MONTGOMERY COUNTY PLANNING DEPARTMENT
THE MARYLAND-NATIONAL CAPITAL PARK AND PLANNING COMMISSION

MEMORANDUM

SUBJECT: Purple Line Functional Plan – Worksession Number One

RECOMMENDATION: Approve selected revisions to Draft Plan.

Figure 2 – Purple Line from Bethesda to Jones Mill Road

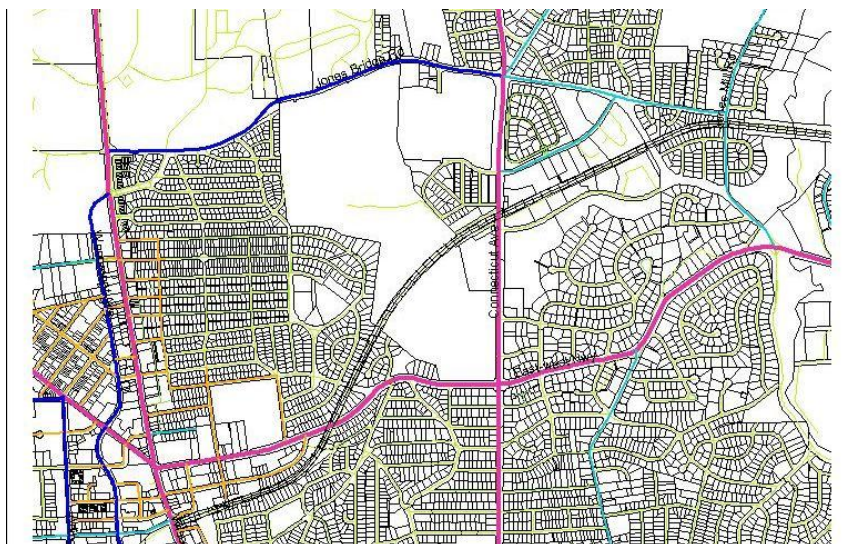
The MTA has begun to identify some preliminary locations (see Figure 2 of this memo) for the traction power substations that are subject to change. The staff believes the MTA should continue to identify these locations throughout preliminary engineering in concert with other technical analysis along the alignment. The Draft Plan (see last paragraph on page 11) acknowledges that the Plan's "dimensions, features, and description are subject to modifications as project planning continues into preliminary engineering, final design, and construction."¹¹ The staff therefore does not recommend that the Functional Plan identify final locations for these facilities.

Figure 3 – Purple Line and Trail @ Pearl Street

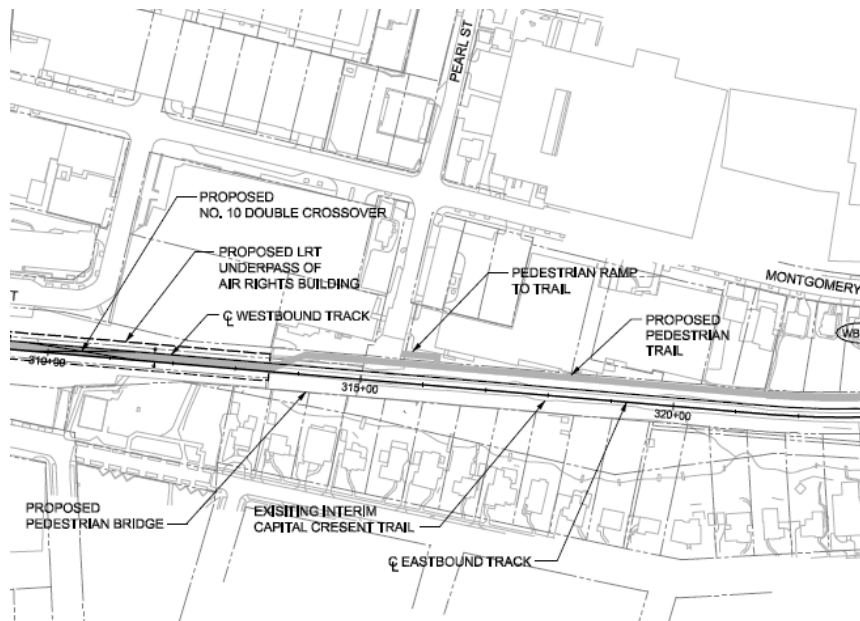
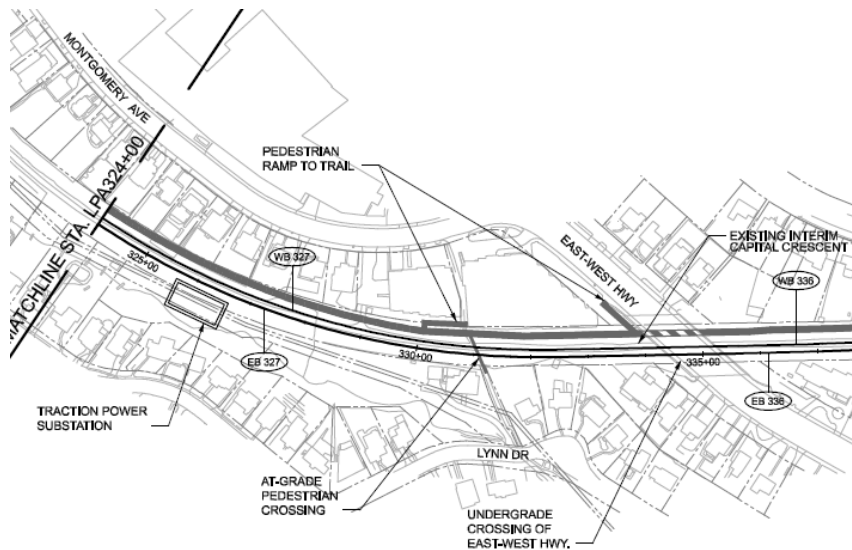
The Draft Plan reflects the LPA as shown in Figures 3 and 4 above and therefore shows the trail on the north side with access points provided via pedestrian ramps on the north side of the right

of way at Pearl Street, Lynn Drive, and East West Highway and via a pedestrian path on the south side at Lynn Drive. The crossing of the right of way at Lynn Drive is at-grade – there is no bridge.¹ There is also no planned station at East West Highway in the Draft Plan.

One issue raised by the Town is proximity to the light rail vehicles – specifically the loss of the buffer provided by the trail on the south side of the right of way along the Town boundary.

The staff therefore does not believe there is any material difference between the north side and the south side when considering proximity to the right of way. If anything, the number and proximity of the residences on the north side in the segment along the Town boundary favor placing the trail (as a buffer if proximity to the train is the major or sole criteria) on the north side – not the south side.

Figure 5 – Lynn Drive Access Point in Current Master Plan

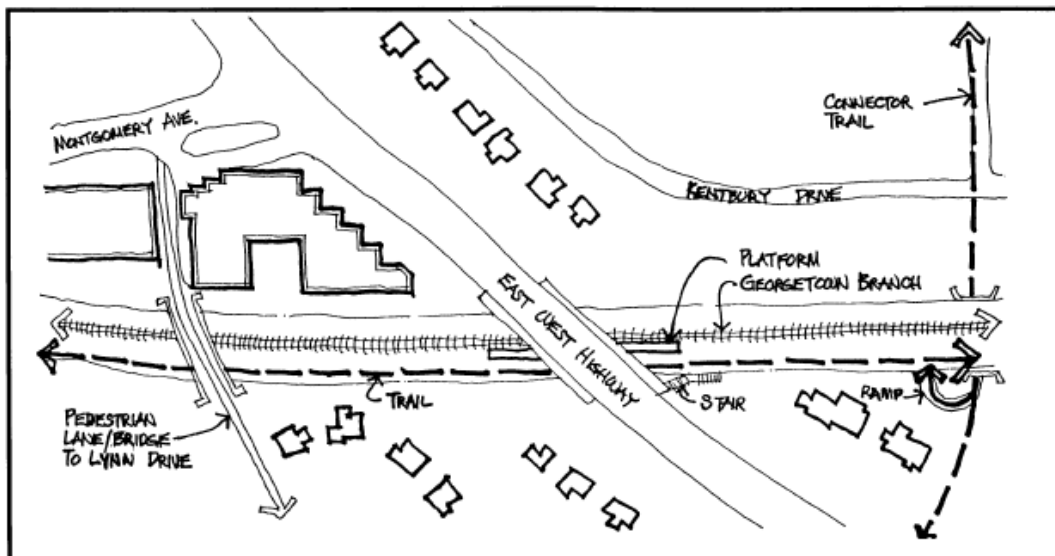
- Constructing a pedestrian overpass at the access point at Lynn Drive (similar to the 1990 Plan concept in Figure 5). Due to space constraints adjacent to the Riviera Apartments, this option might preclude access between the trail and Montgomery Avenue via the path next to the Riviera Apartments.

Figure 6 – Residential Proximity to Georgetown Branch Right of Way

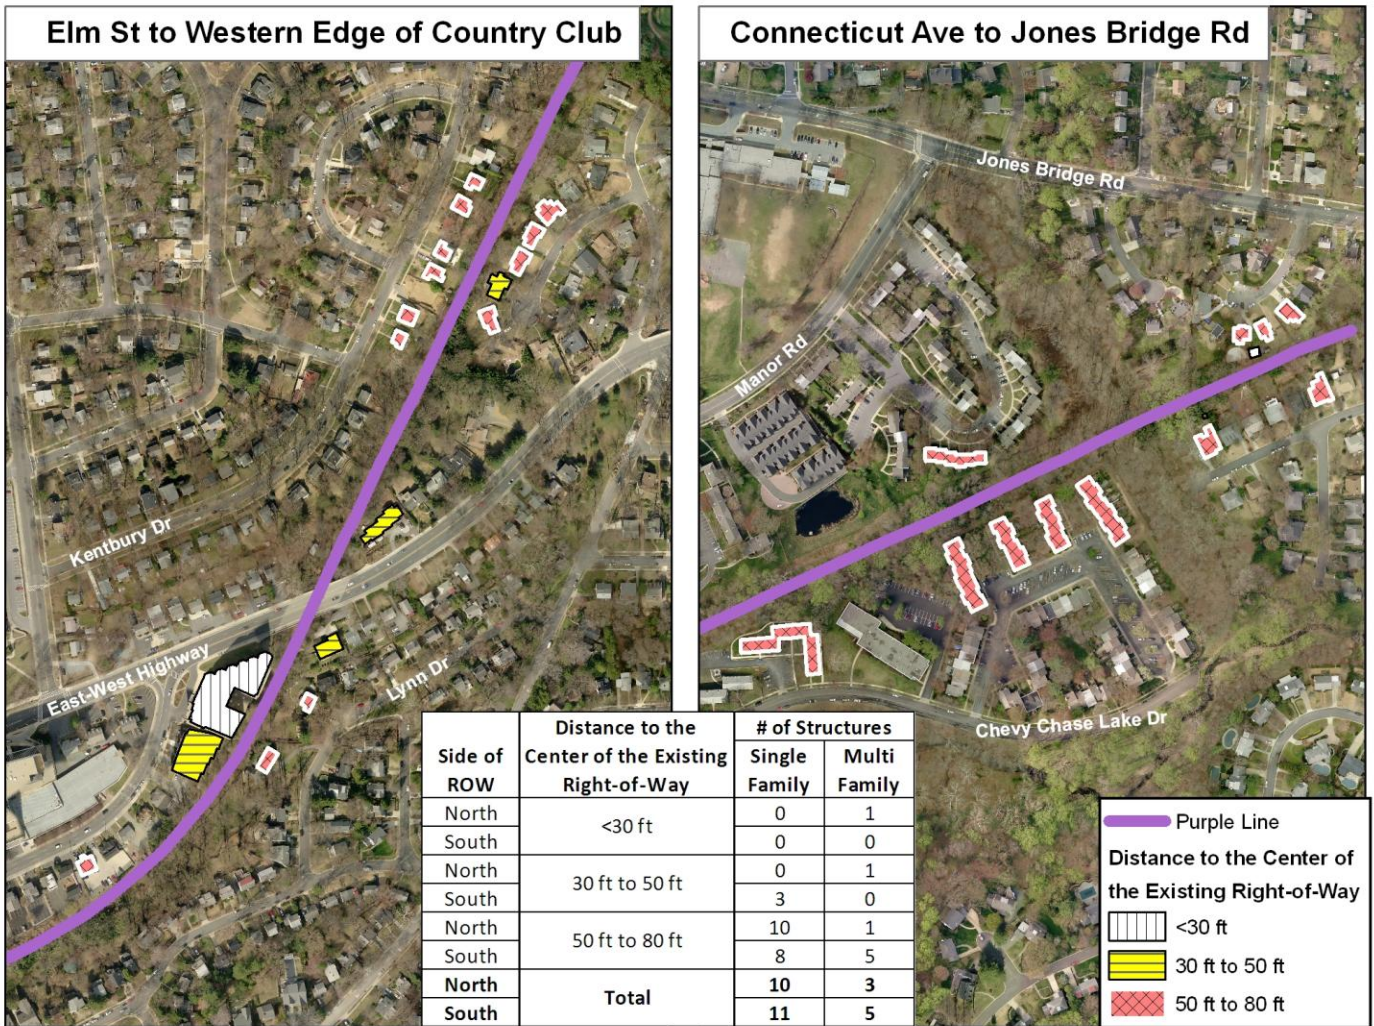
A summary of the findings is presented in Figure 6 below. As noted in the summary, there is no significant difference in the number of parcels when considering the entire segment from Elm Street Park to Jones Mill Road. Within the segment that includes the Town boundary to the south, there are two more single family homes than on the north side but there are more residences (multi-family) on the north and those residences are closer to the centerline.

Figure 10 – Entrance to Trail Access from Montgomery Avenue

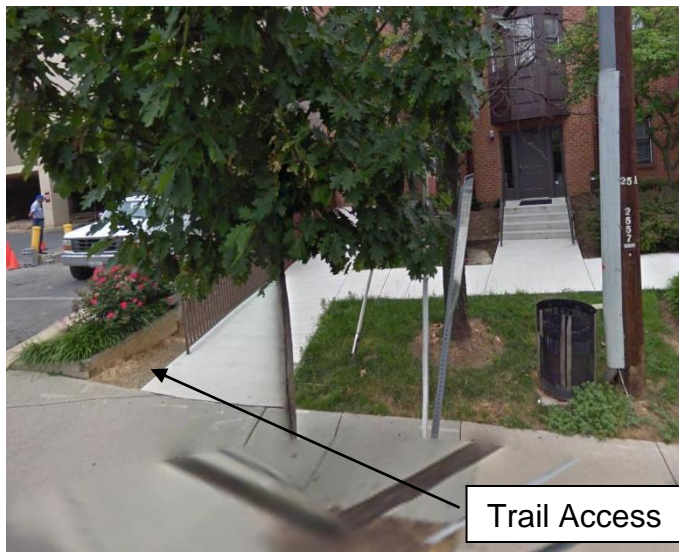
The constraints on the north side of the right of way are similar. The path west of the Rivera Apartments is even narrower than the path on the south side as noted in Figure 10 below.

Figure 12 – Purple Line and Trail Over Colesville Road and Purple Line Platform at Silver Spring Transit Center (Looking Southeast toward Bonifant Street) – Along With Current Conditions Looking In Same Direction

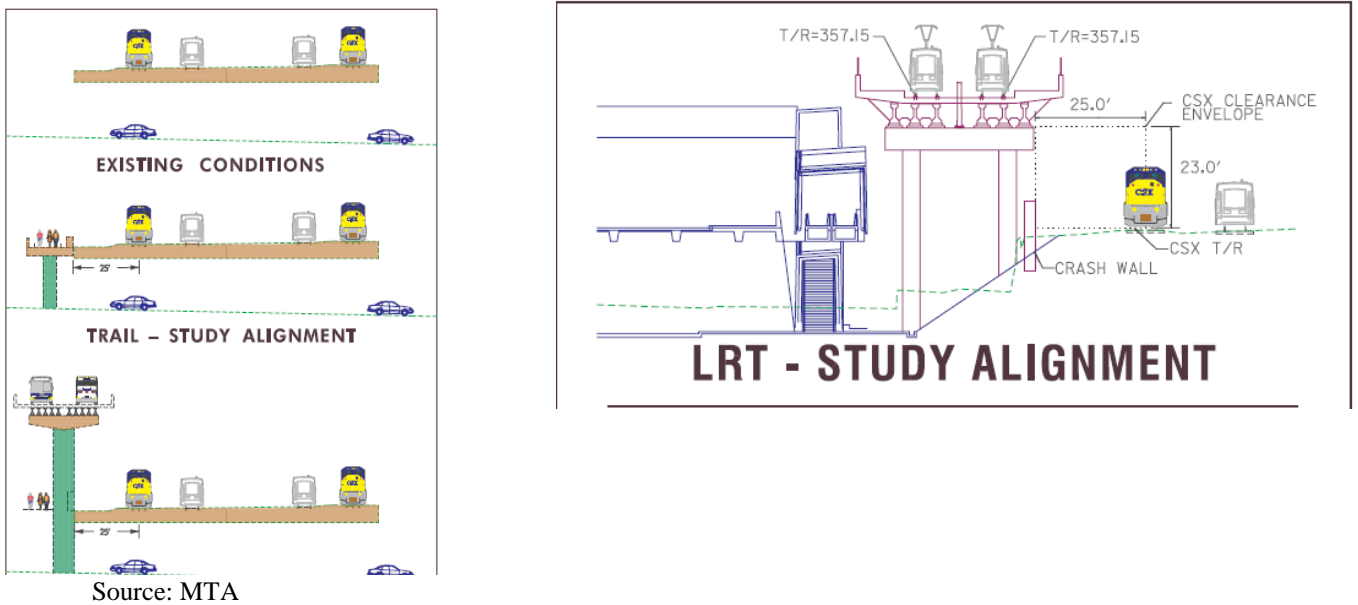
Currently, the MTA Project Team is examining how and where to bring the (eastbound) Capital Crescent trail down (after crossing Colesville Road) to grade to directly connect with the Met Branch Trail, while minimizing conflicts with pedestrians in the plaza area in front of the Metrorail station entrance and transit passengers on the bridge connecting the Transit Center and the MARC tracks. A look at the Transit Center (from Colesville Road) is provided below in Figure 14.⁷

The MTA has identified three potential solutions in which the Capital Crescent Trail is elevated over the plaza area and then either passes: a) over, b) under, or, c) intersects the MARC bridge, before connecting with the Met Branch Trail at grade. The last example is not ideal because it brings higher speed cyclists and high-volumes of transit passengers into a common area, creating safety concerns.

- b. Replace the 6th bullet under the Capital Crescent Trail section on page 20 with “the trail will cross Colesville Road on a bridge and enter the Silver Spring Transit Center area between the Metrorail/MARC tracks and the bus bays at or near an elevation close to the second level of the Transit Center.”**
- c. Replace the 7th bullet under the Capital Crescent Trail section on page 20 with “the trail will provide access to the Transit Center for rail and bus users.”**
- d. Add the word “area” after “Transit Center” in the sentence associated with the next to last bullet under the Capital Crescent Trail section on page 20.**

Figure 14 – Silver Spring Transit Center

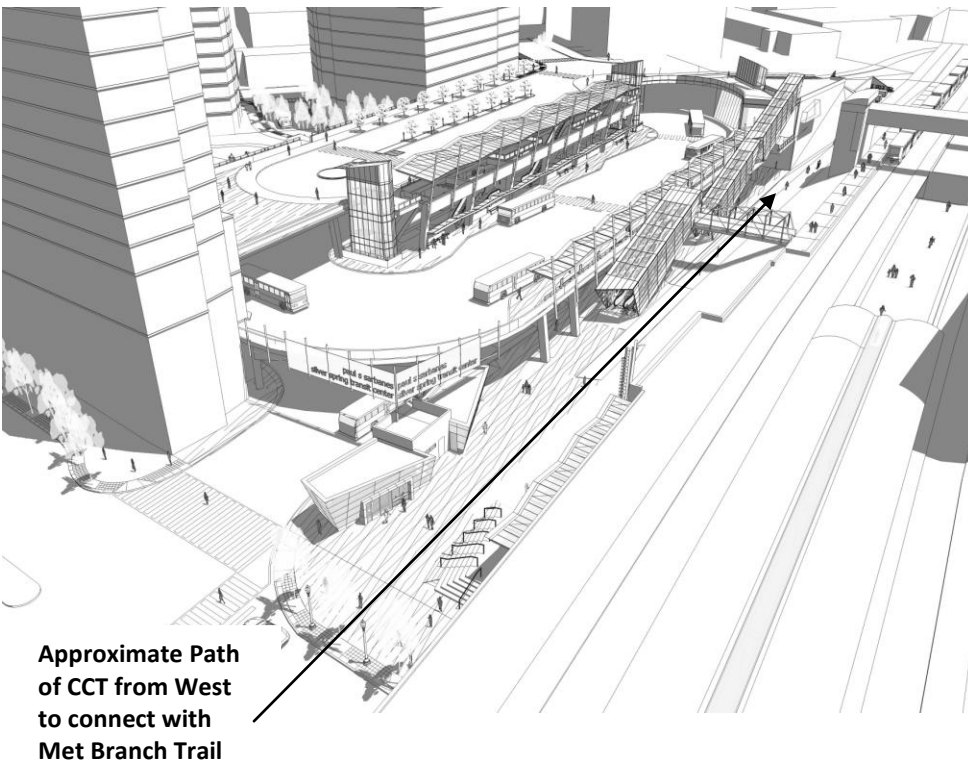
This issue is important for a number of reasons. The respective trails make up a significant part of the regional trail system. There are many pedestrians and some of them will be in an unfamiliar area – looking for information and maybe in a hurry to get to a bus or train. **Every effort needs to be made to insure a direct and safe connection that avoids conflict between trail users and transit passengers.** The staff agrees that the Plan wording should be revised to better describe the overall location of planned connections.

The staff recommends modifying the existing wording on page 20 of the Draft Plan related to where the trails will connect at the Silver Spring Transit Center:

Figure 15 – Purple Line along Bonifant Street

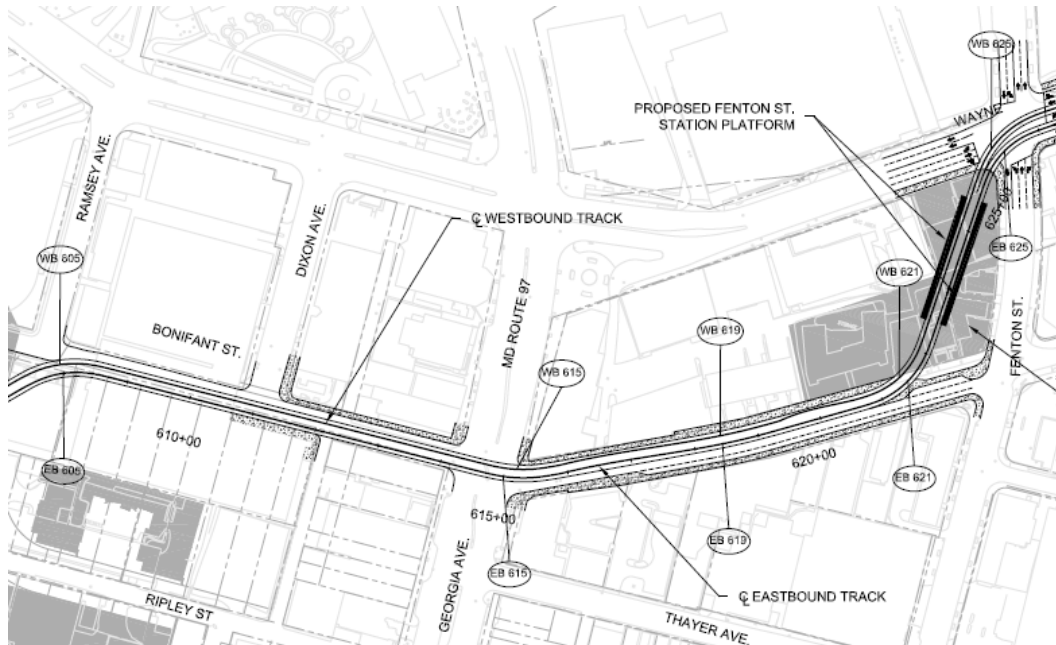
The staff agrees that the current wording in the plan needs to be revised to more clearly distinguish between Bonifant Street on the east and west sides of Georgia Avenue and that the issue of the ultimate configuration on the east side remains an operational element requiring further review. The staff therefore recommends:

- e. **In Table 12 on page 23, delete the paragraph related to parking and replace with “On-street parking along Bonifant Street east of Georgia Avenue may be prohibited to accommodate the Purple Line. Some of the on-street parking could be retained if the street was restricted to one lane of vehicular travel. Recommendations for traffic**

operations on Bonifant Street will be finalized during later phases of project planning.”

Figure 17 – Purple Line at Fenton Street and Wayne Avenue

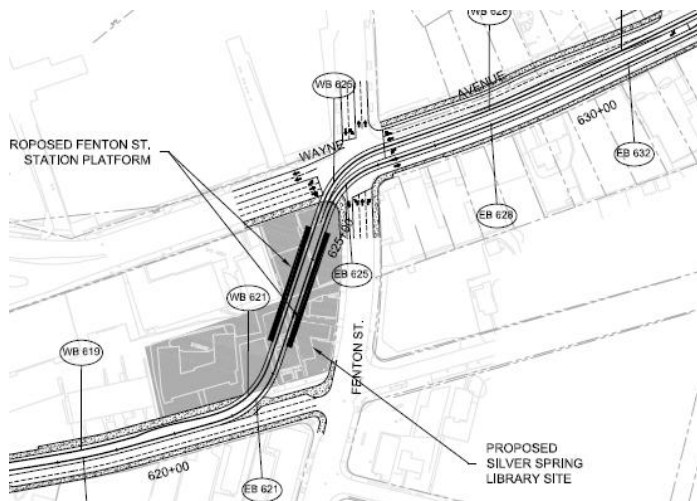
There are locations along Wayne Avenue where it is going to be difficult to devote more than 13 feet to any combination of path, sidewalk and/or buffer. One location is on the north side of Wayne Avenue where Whole Foods is located. The current concept plan for this area is shown below in Figure 17 and existing Green Trail on the north side of Wayne Avenue is shown in Figure 18. The Green Trail is also shown on the north side of Wayne Avenue in Figures 19 and 20 in the following discussion on the Dale Drive Station.

The MTA is currently reviewing the plans to determine the areas where additional room for the Green Trail could be provided without requiring additional right of way. In a preliminary review conducted by staff, there appears to be some areas where an additional space could be devoted to the Green Trail. There are other areas like the area shown above where it is unlikely that additional space will be available.

The staff recommends that no change be made in the plan that would suggest anything other than a minimum of thirteen feet of combined path, sidewalk or buffer be dedicated to the Green Trail in the area where it is adjacent to the Purple Line.

The staff does believe that the Plan’s current wording of at least eight feet wide does not make it clear that the current planning is based upon providing a minimum of a total of 13 feet from the curb line on the north side of Wayne Avenue for some combination of path, sidewalk and buffer. Staff therefore recommends that the following modification be made to the Public Hearing Draft Plan:

- f. Delete the phrase “at least eight feet wide” on page 24 and insert a new sentence:**

Figure 19 – Purple Line at Wayne Avenue and Dale Drive without Station

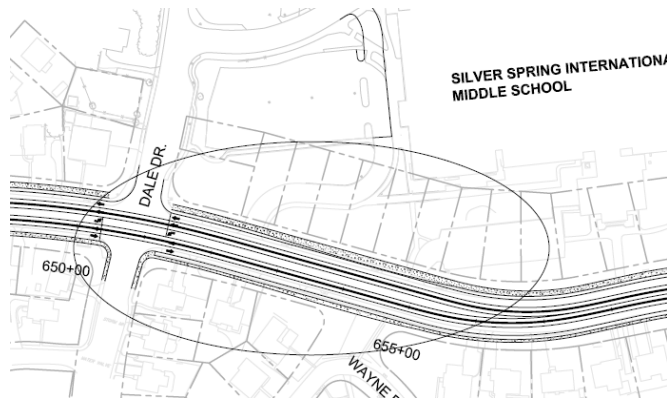
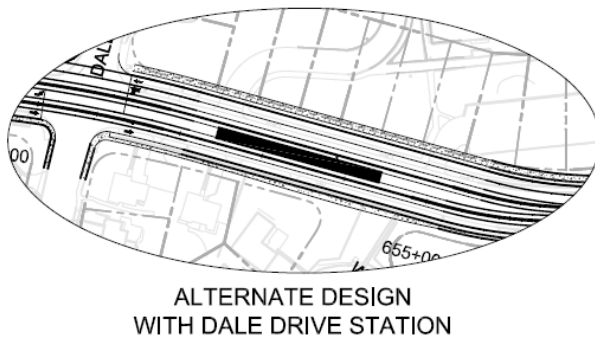
It appears in reviewing the concept plans in Figure 19 and 20 that there is additional right-of-way acquisition required on the north side of Wayne Avenue east of Dale Drive if there is a station platform. While that is understandable, the staff has interpreted the County Council recommendation as requesting that the initial construction and design include all of the area that would ultimately be required to later construct the platform and other supporting facilities without requiring additional land acquisition. **The staff will review this issue with the MTA Project Team at the worksession.**⁹ This issue is also related to the ultimate configuration of the Silver Spring Green Trail on the north side of Wayne Avenue (see following discussion).

Staff recommends that the Planning Board retain the language in the Draft Plan with respect to the Dale Drive station and show the station location on Plan maps. Staff also recommends that the MTA continue to examine the issue in subsequent model runs with an emphasis on refining how the model accounts for walk access to station in close proximity of one another.
